**Review and Evaluation of Characterization Data Provided
for Fansteel Corporation, Muskogee, Oklahoma**

**Thomas Fredrichs
U.S. NRC**

ICF Consulting

November 15, 2002

Figure 4 February 1993 Shallow Groundwater Sampling Results

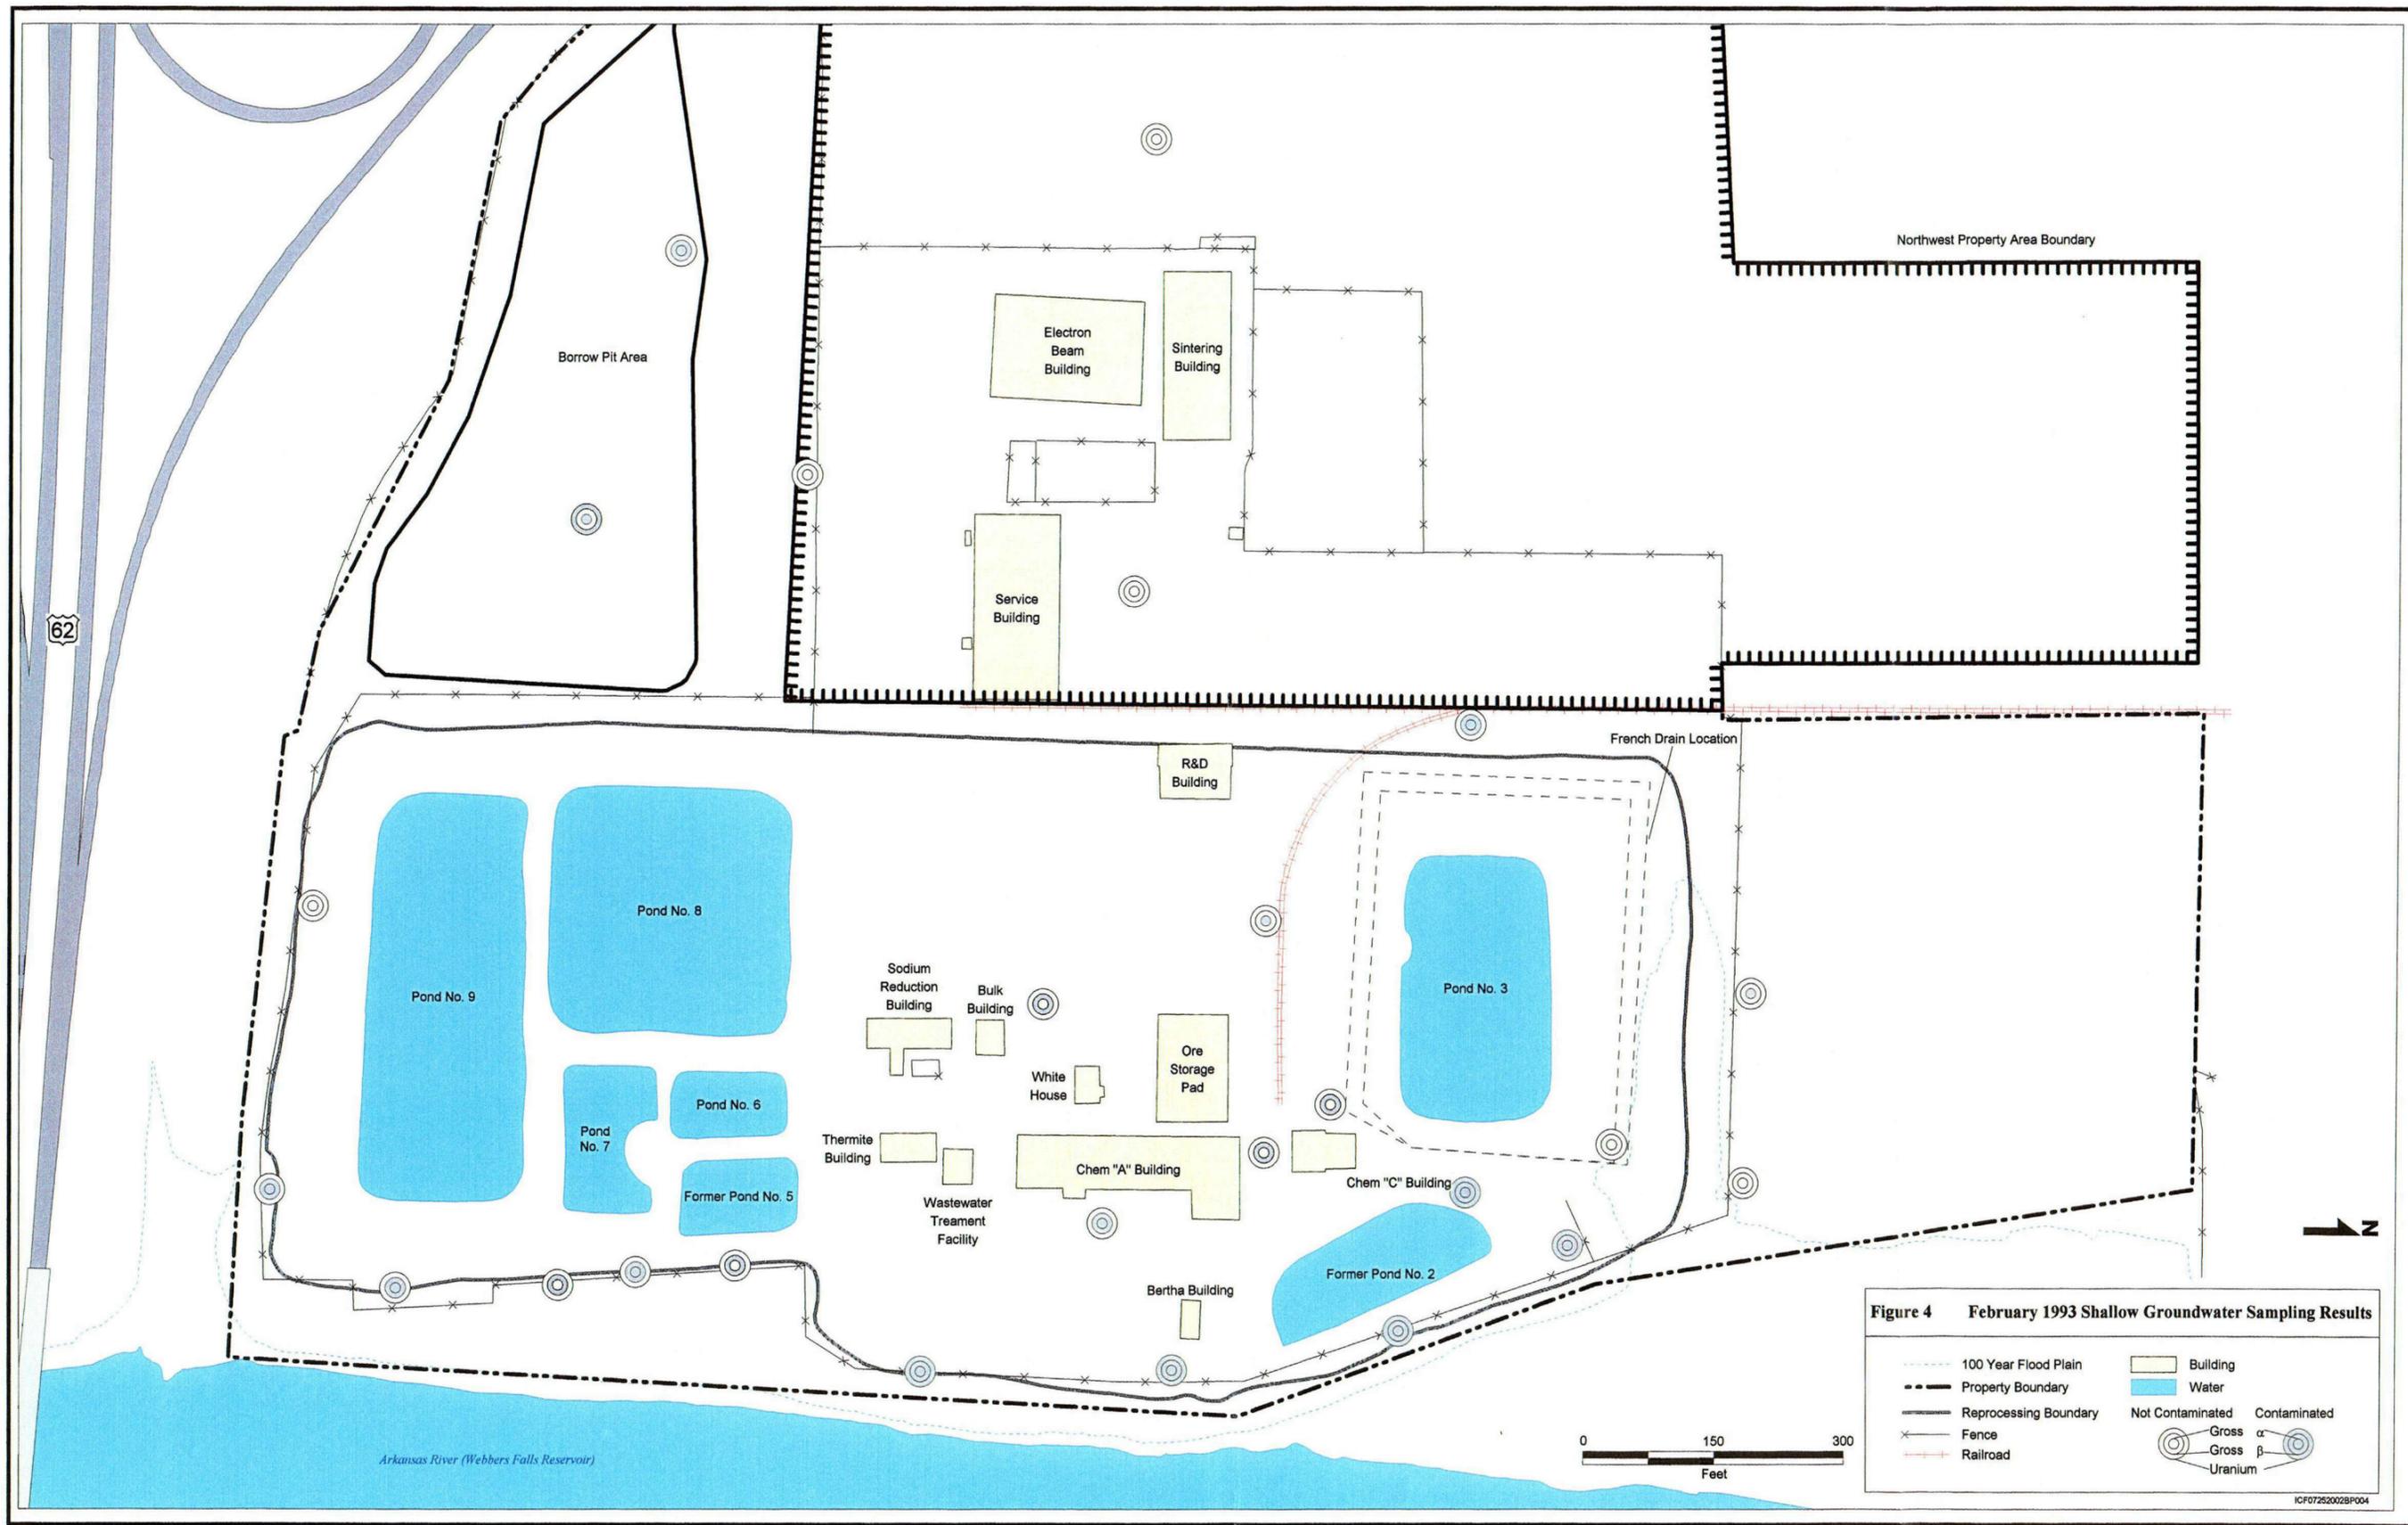
Table 11 shows that in February 1993 four of the seven upgradient wells had elevated levels of gross alpha, and that 10 of the 18 downgradient wells had elevated levels of gross alpha. Figure 4 shows gross alpha, gross beta, and uranium contamination in the shallow wells. Five of the downgradient wells that did not have elevated gross alpha levels had elevated gross beta levels.

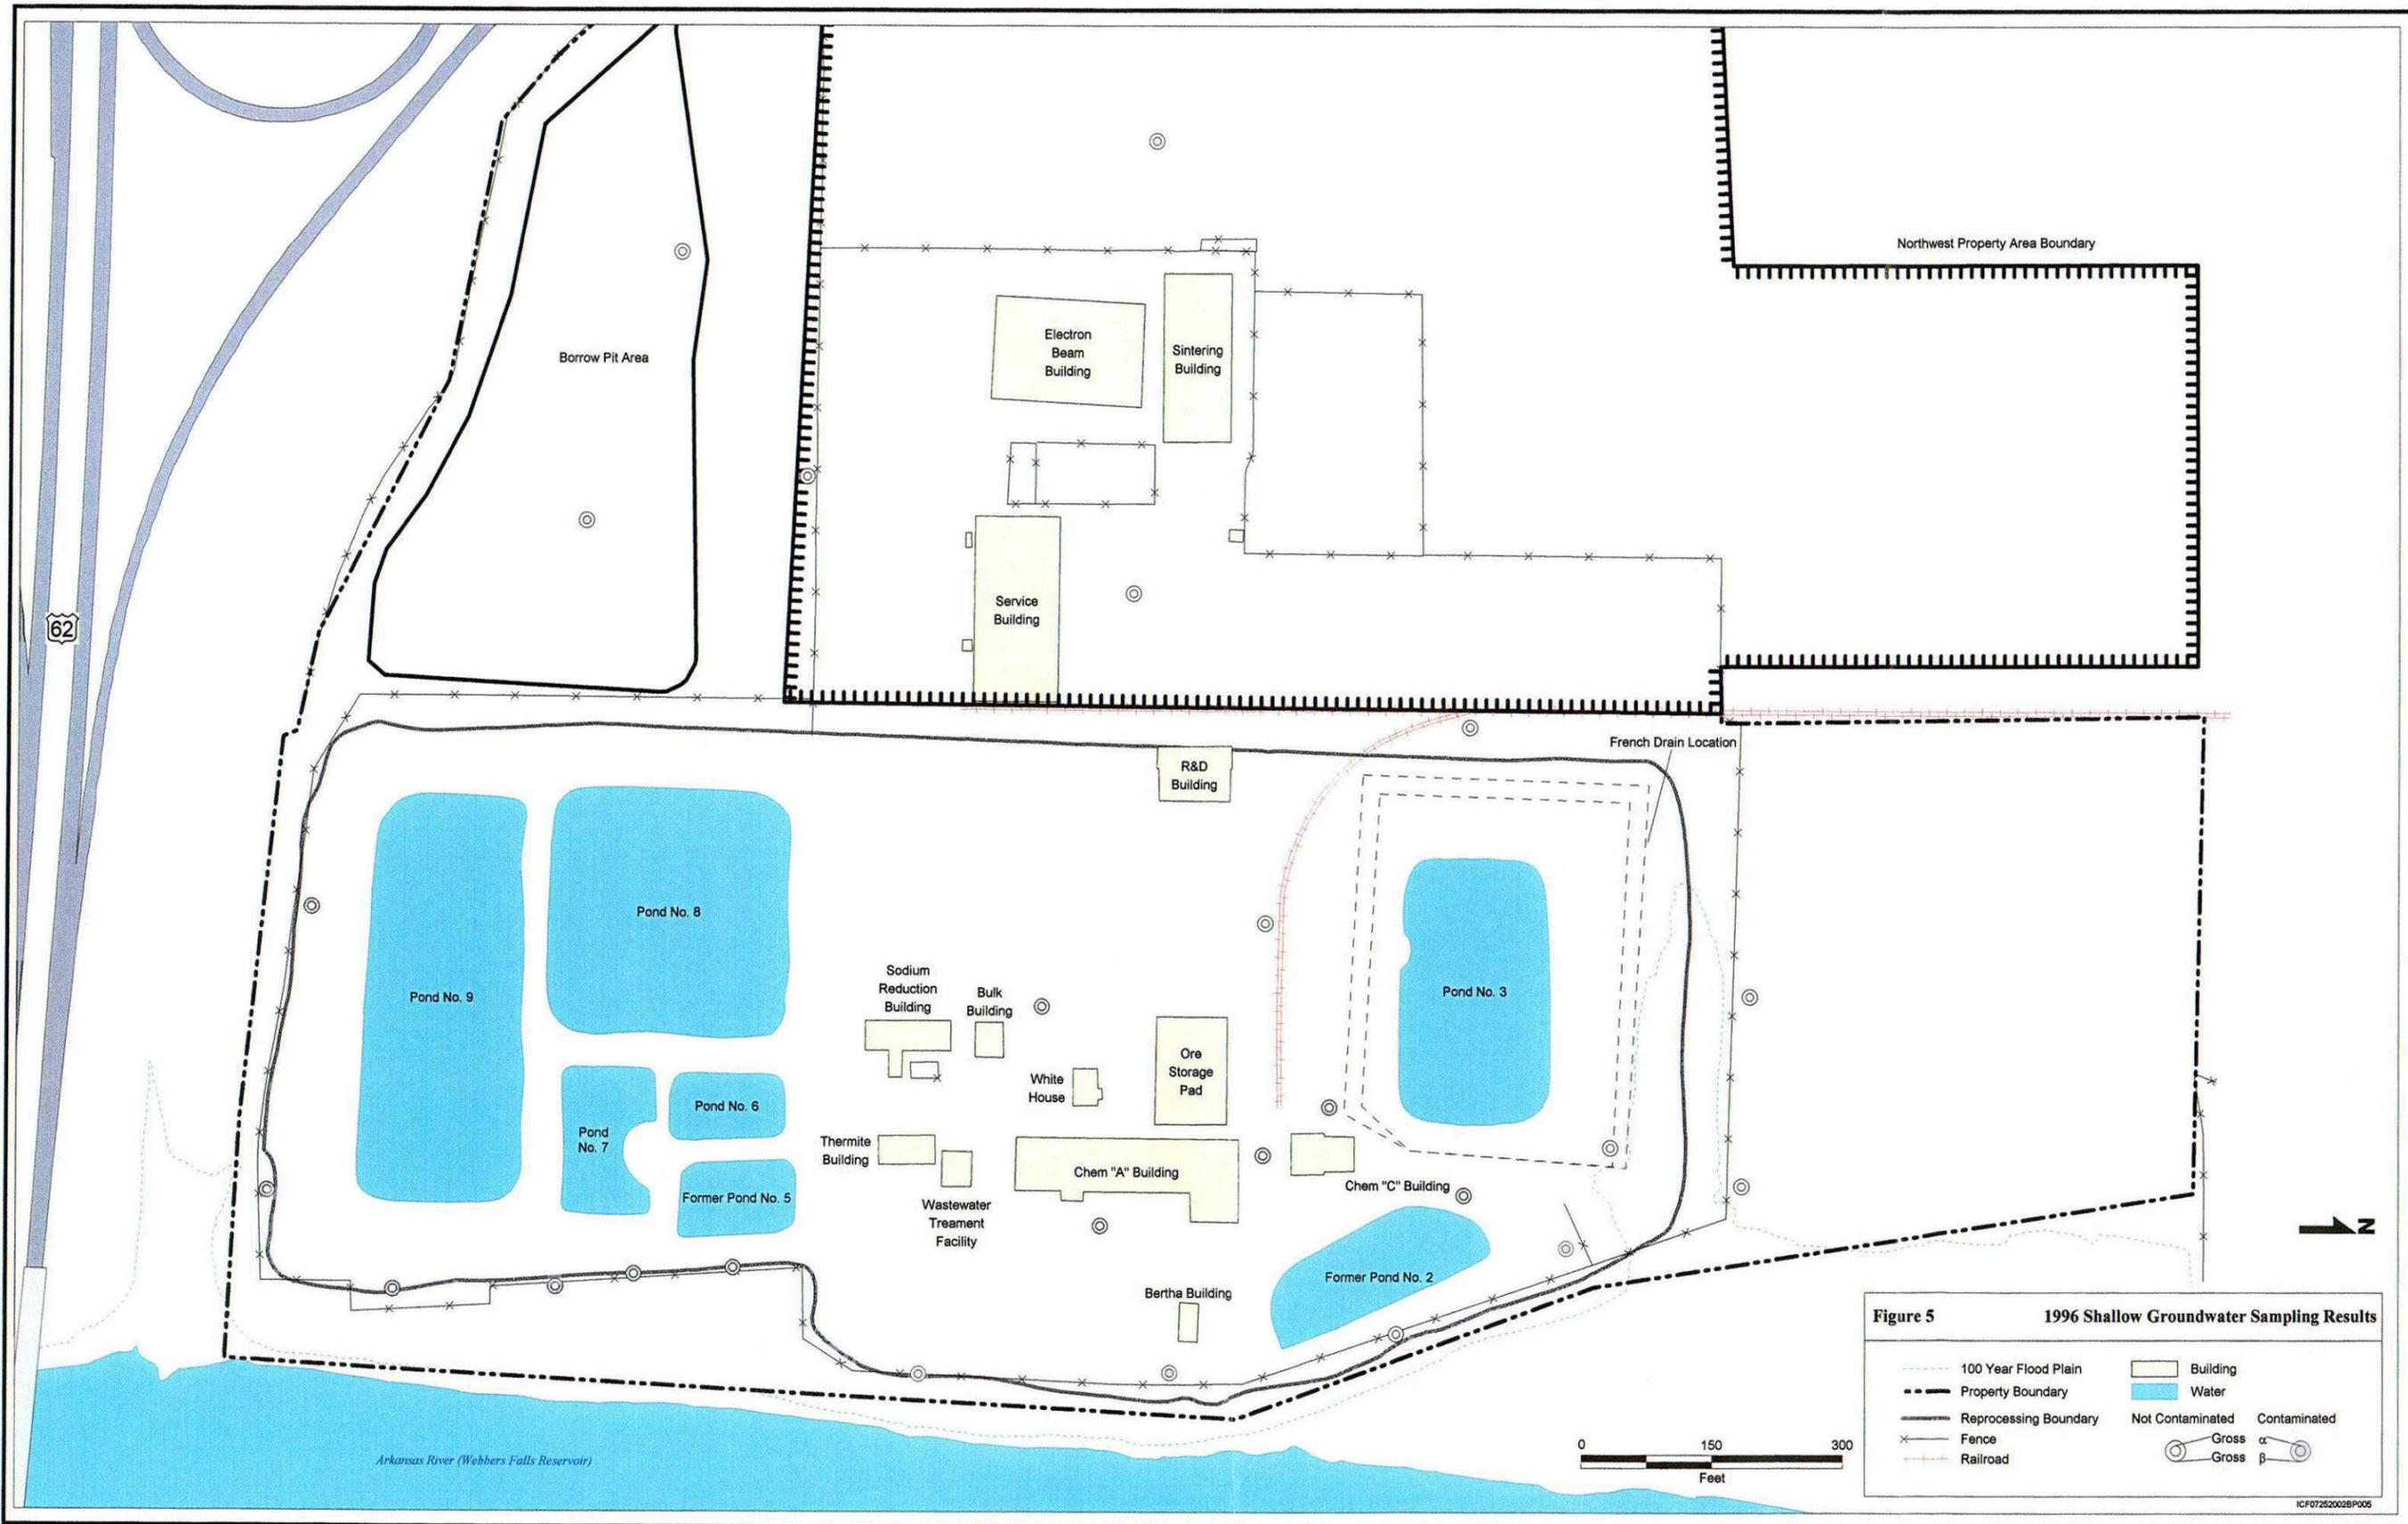
Table 14 shows that in 1996, which is seven years after Fansteel ceased operations, there is still significant groundwater contamination. Figure 5 shows gross alpha and gross beta contamination in the shallow wells for samples collected in 1996. The data in Table 14 shows that none of the seven upgradient wells have an average gross alpha or gross beta concentration above the action levels. This table also shows that four of the 18 downgradient wells have average gross alpha concentrations above the action level, and that only two other downgradient wells had one sample above the action level. Eleven wells had average gross beta concentrations above the action level of 50 pCi/l that did not have elevated gross alpha concentrations. As Earth Sciences has hypothesized, the samples with elevated gross beta but not elevated gross alpha are due to naturally occurring deposits of K-40 and thus the groundwater is not necessarily impacted by Fansteel's operations. Three of the four wells with elevated gross alpha also had elevated levels of gross beta. The monitoring well located in the borrow pit area, MW-56S, did not have elevated gross beta levels.
